Formal Interpretations *Guidelines for Design and Construction of Hospitals*, 2018 edition

REQUEST

Guidelines edition: 2018 Hospital

Paragraph reference: 2.2-2.6.2.2 (2)

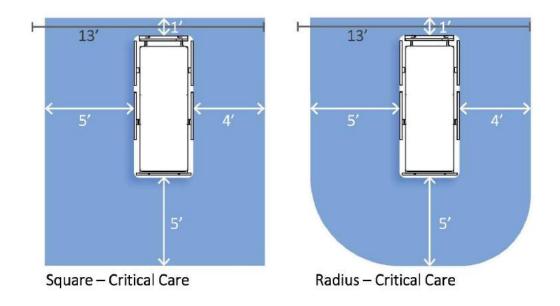
Question: In Section 2.2-2.6.2.2 (2), regarding clearances for critical care patient care stations, does the 5-foot clearance requirement at the foot of the bed only require clearance for the width of the bed itself, or is the clearance to be extended to include transfer side width (5 feet) and non-transfer side width (4 feet), such that the width of the clearance at the foot of the bed totals 14 feet?

Response: The clearance requirement at the foot of the bed is intended to create sufficient space for care of the patient. Space is needed around the corners of the bed to allow access and movement for equipment, staff, and family members. Staff must be able to easily move around the bed. As well, space is needed for IV and pain management systems, warmers, etc., and for use of patient lifts and gurneys. To accommodate these needs, the full dimension at the foot needs to be as wide as the clearances on the sides of the bed; however, the squared-off space this creates could be rounded off to accommodate structural or other non-movable encroachments. This response applies to all places in the *Guidelines* where clearance requirements are provided. The diagrams below may help clarify this response.
